## Product Change Notification(PCN)

### V5220XX

### 32x20mm Extruded heatsinks black anodized material AL6063

**Change Notification:** PCN 20190403 V5220XX

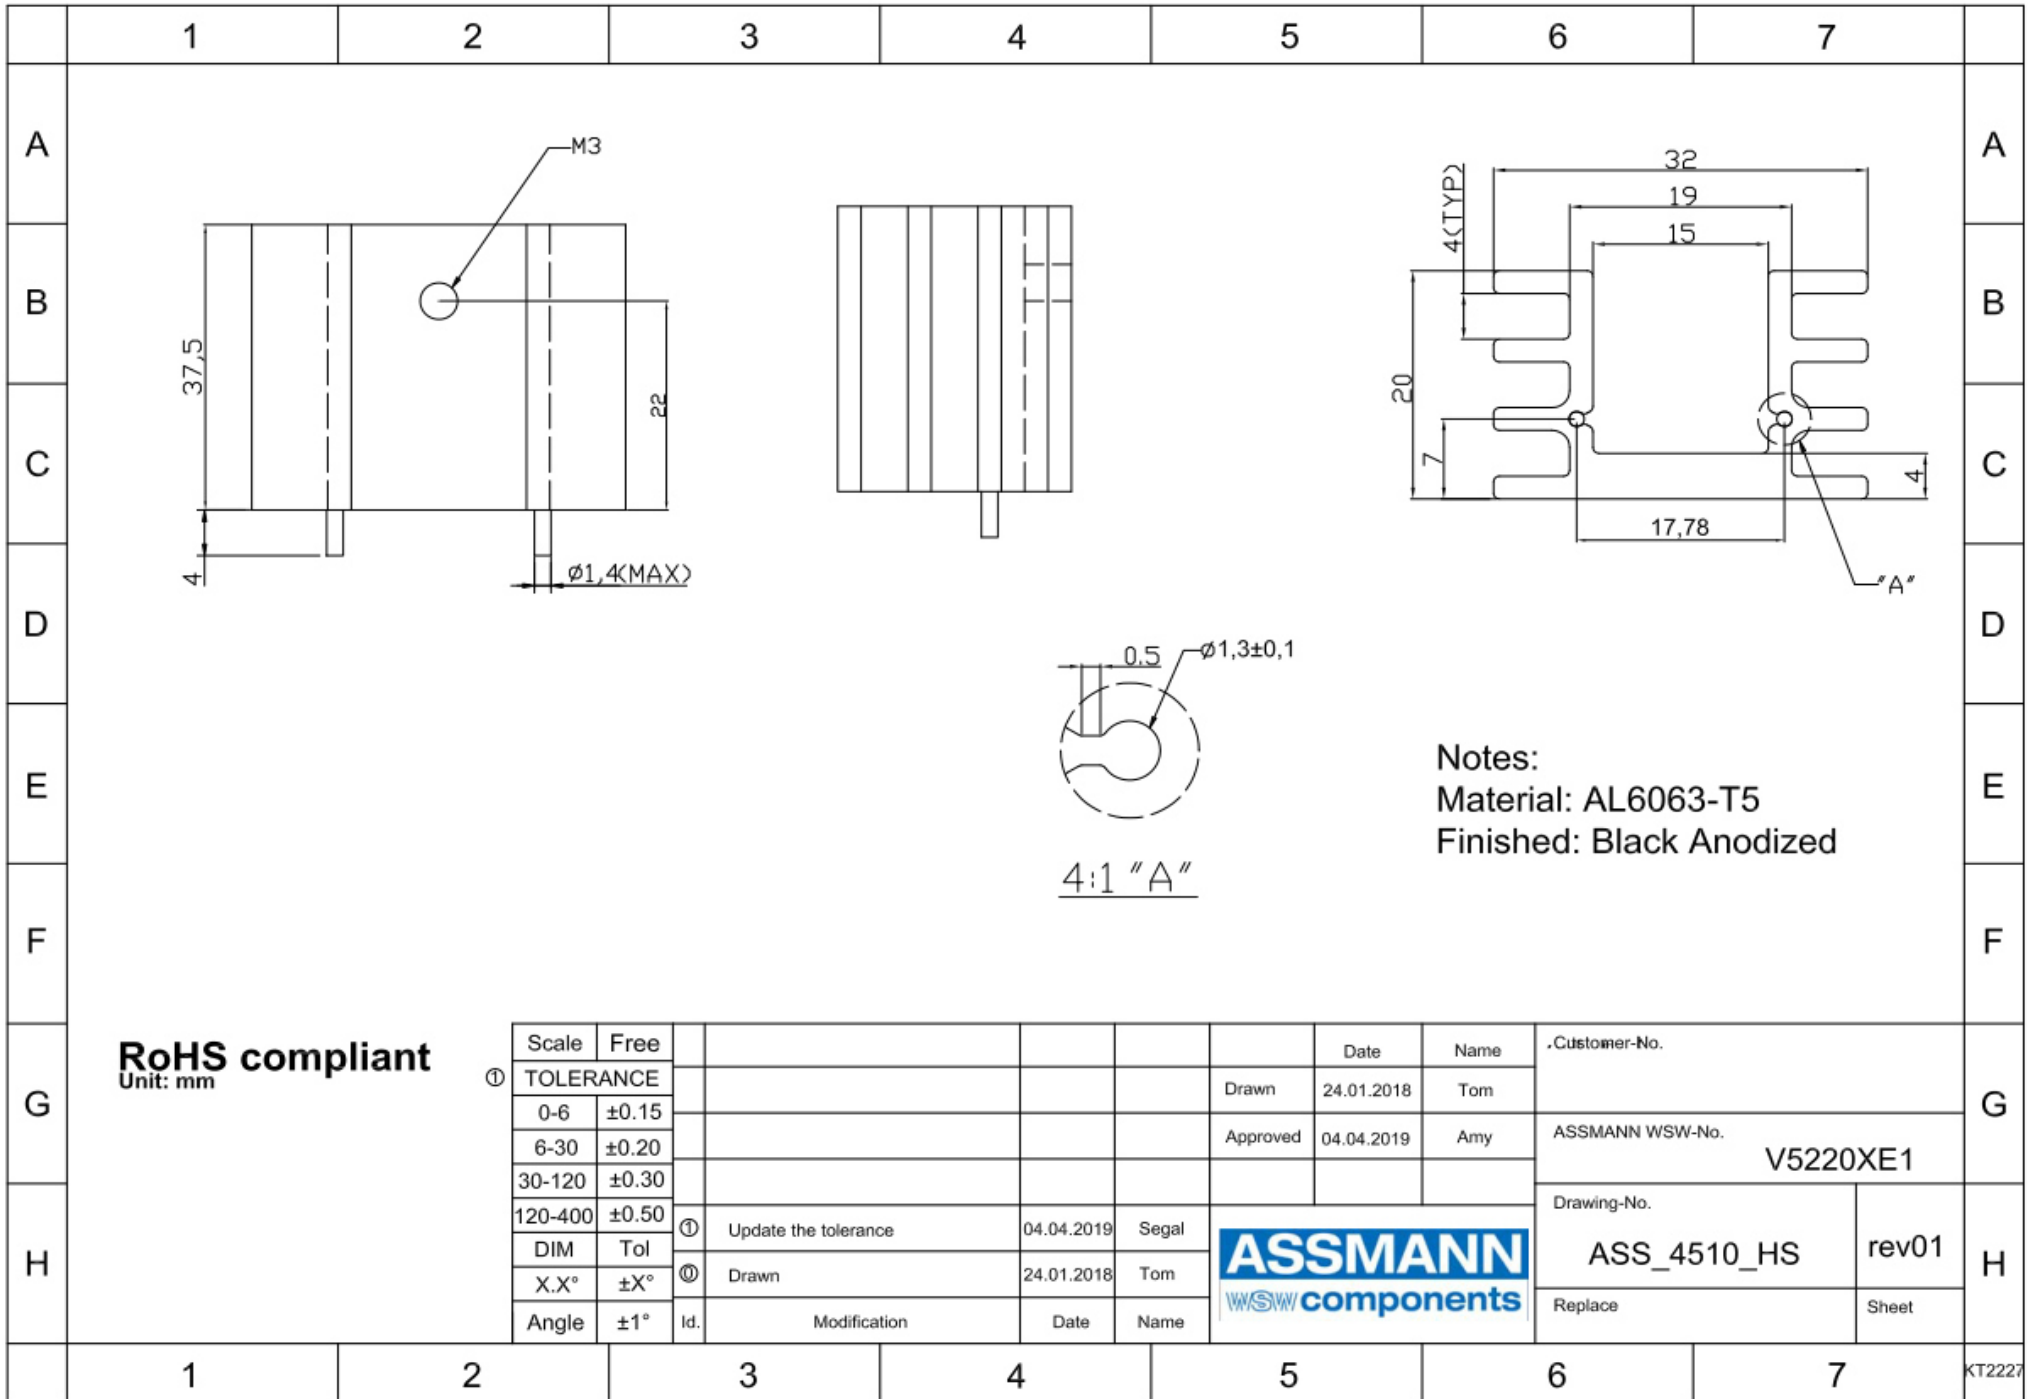
**Description of changes:** Change of production plant  
3. Change of tolerance  
4. Draw.-No. ASS\_4510\_HSrev01 substitutes ASS\_4510\_HSrev00  
5. Draw.-No. ASS\_0498\_HSrev05 substitutes ASS\_0498\_HSrev04

V5220XX	Old version	V5220XX	New version																																				
Change of tolerance		Change of tolerance																																					
<table border="1"> <thead> <tr> <th>Scale</th> <th>Free</th> </tr> </thead> <tbody> <tr> <td colspan="2">TOLERANCE</td> </tr> <tr> <td></td> <td></td> </tr> <tr> <td></td> <td></td> </tr> <tr> <td>UNIT</td> <td>±0.20</td> </tr> <tr> <td>DIM</td> <td>TOL</td> </tr> <tr> <td>X.°</td> <td>±X°</td> </tr> <tr> <td>X.X°</td> <td>±X°</td> </tr> <tr> <td>Angle</td> <td>TOL</td> </tr> </tbody> </table>		Scale	Free	TOLERANCE						UNIT	±0.20	DIM	TOL	X.°	±X°	X.X°	±X°	Angle	TOL	<table border="1"> <thead> <tr> <th>Scale</th> <th>Free</th> </tr> </thead> <tbody> <tr> <td colspan="2">TOLERANCE</td> </tr> <tr> <td>0-6</td> <td>±0.15</td> </tr> <tr> <td>6-30</td> <td>±0.20</td> </tr> <tr> <td>30-120</td> <td>±0.30</td> </tr> <tr> <td>120-400</td> <td>±0.50</td> </tr> <tr> <td>DIM</td> <td>TOL</td> </tr> <tr> <td></td> <td></td> </tr> <tr> <td>Angle</td> <td>±1°</td> </tr> </tbody> </table>		Scale	Free	TOLERANCE		0-6	±0.15	6-30	±0.20	30-120	±0.30	120-400	±0.50	DIM	TOL			Angle	±1°

Scale	Free																																						
TOLERANCE																																							
UNIT	±0.20																																						
DIM	TOL																																						
X.°	±X°																																						
X.X°	±X°																																						
Angle	TOL																																						
Scale	Free																																						
TOLERANCE																																							
0-6	±0.15																																						
6-30	±0.20																																						
30-120	±0.30																																						
120-400	±0.50																																						
DIM	TOL																																						
Angle	±1°																																						
<p>For detail, please take attached new drawing for reference: ASS_4510_HSrev01            ASS_0498_HSrev05</p>
